Final Drainage Report

Tract DD, Hannah Ridge at Feathergrass Filing No. 1 El Paso County, Colorado

Resubmitted: May 24, 2021

PCD File Number: **PPR-21-017**

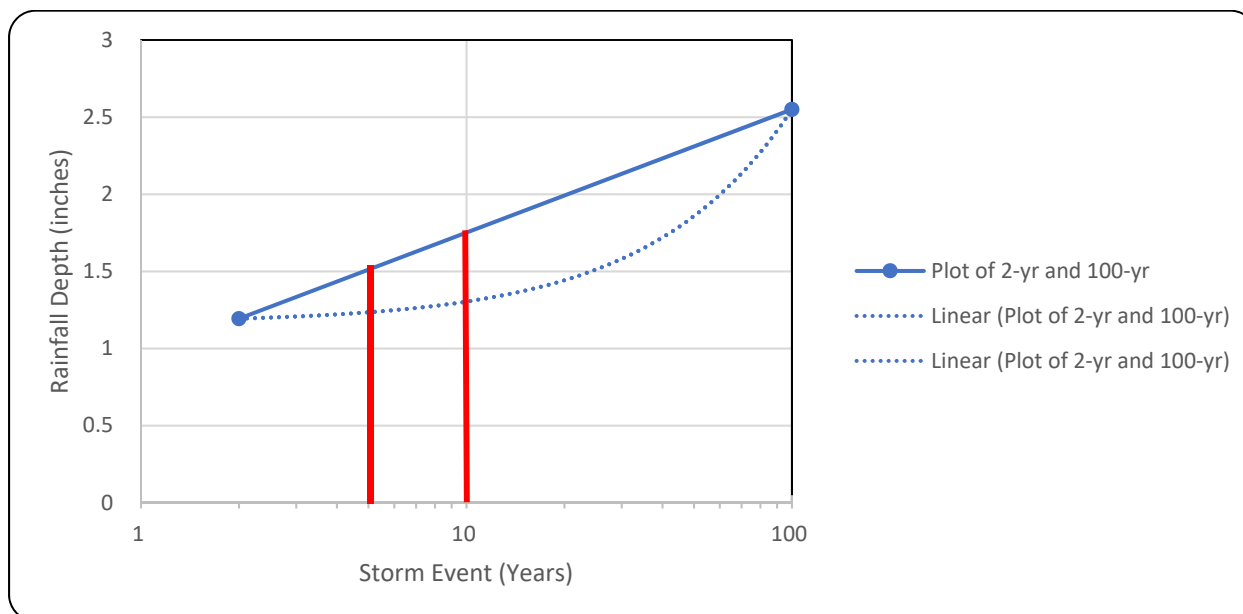
change to 1.75
